## PIC16C505 Rev. A Silicon/Data Sheet Errata

The PIC16C505 parts you have received conform functionally to the Device Data Sheet (DS40192C), except for the anomalies described below.

**FIGURE 1: PIC16LC505 VOLTAGE-FREQUENCY GRAPH,  $-40^{\circ}\text{C} \leq T_A \leq 0^{\circ}\text{C}$**

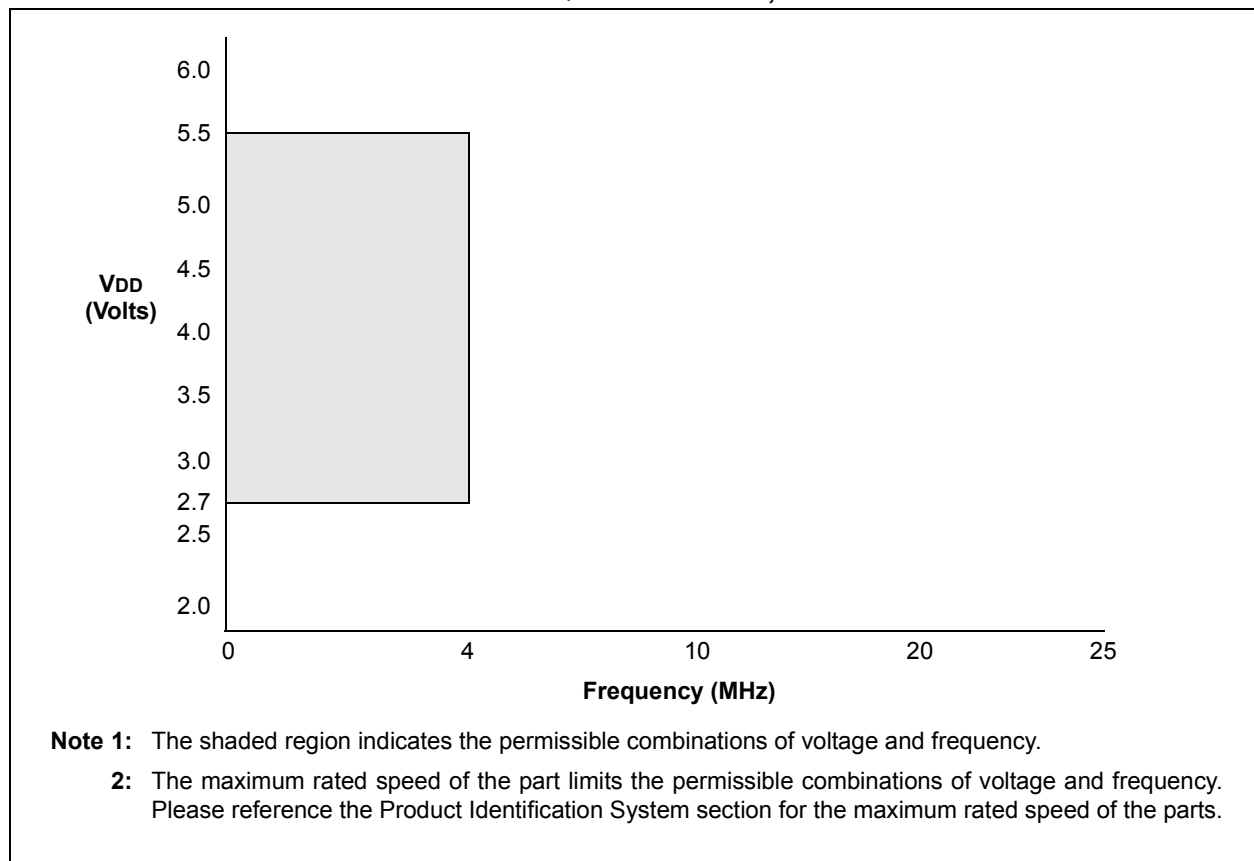
### 1. Module: Voltage Frequency Graphs

Use the following graphs for the respective graphs in the Electrical Specification Section.

#### CLKIN/CLKOUT PIN STATES WHEN $\overline{\text{MCLR}}$ ASSERTED

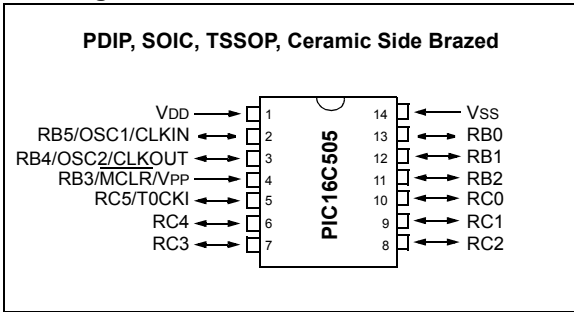
## 4. Module: Reset (CLKIN/CLKOUT)

For the section titled "Reset", additional information is provided on OSC1/CLKIN and OSC2/CLKOUT pin states during a  $\overline{\text{MCLR}}$ .

When  $\overline{\text{MCLR}}$  is asserted, the state of the OSC1/CLKIN and CLKOUT/OSC2 pins are as follows:

Oscillator Mode	OSC1/CLKIN Pin	OSC2/ CLKOUT Pin
EXTRC, CLKOUT on OSC2	OSC1 pin is tri-stated and driven by external circuit	OSC2 pin is driven low
EXTRC, OSC2 is I/O	OSC1 pin is tri-stated and driven by external circuit	OSC2 pin is tri-state input
INTRC, CLKOUT on OSC2	OSC1 pin is tri-state input	OSC2 pin is driven low
INTRC, OSC2 is I/O	OSC1 pin is tri-state input	OSC2 pin is tri-state input
